LEE'S SUMMIT MIDDLE SCHOOL #4
LEE'S SUMMIT R-7 SCHOOL DISTRICT
1001 SE BAILEY ROAD
LEE'S SUMMIT, MO 64881

PACKAGE 2 - STRUCTURAL & SITE UTILITIES
ISSUED FOR PERMIT
08/28/20

PR002R 01.14.21
CPR 1 12.16.21
ASI-40 02.10.22

STANDARD DETAILS

ELEVATION VIEW

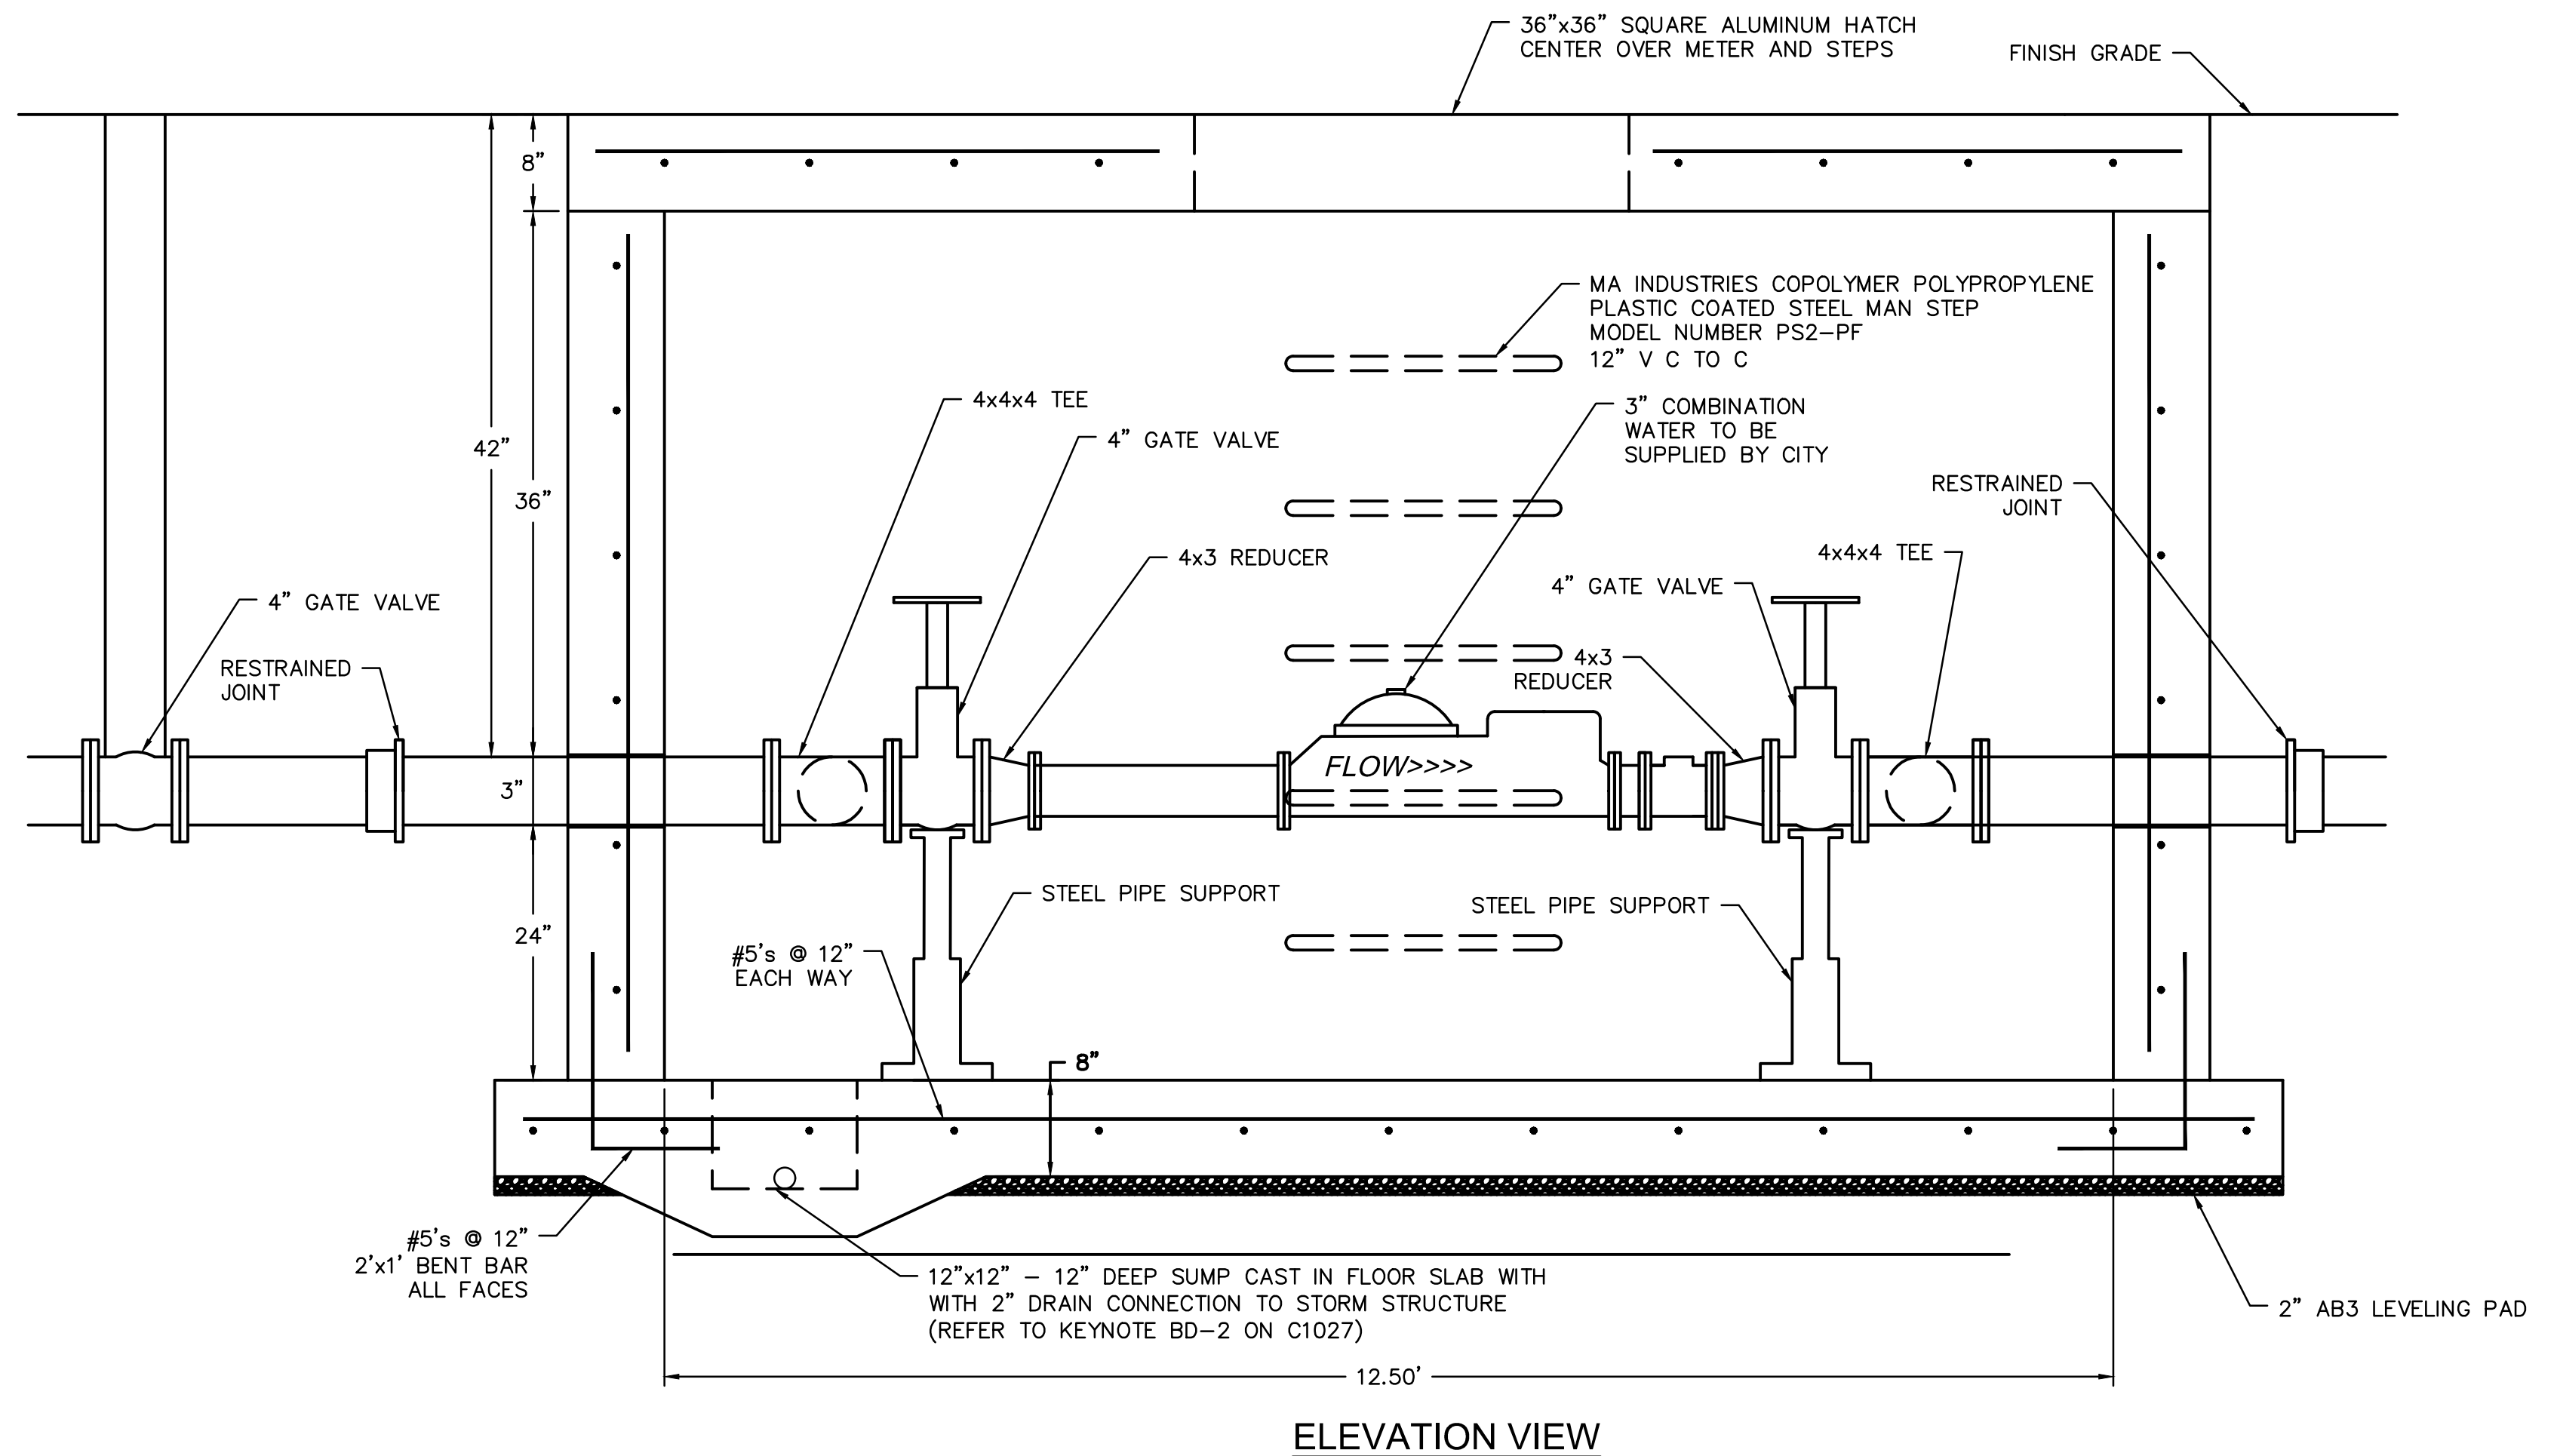
MOVED WATER VAULT DETAILS TO C1050A
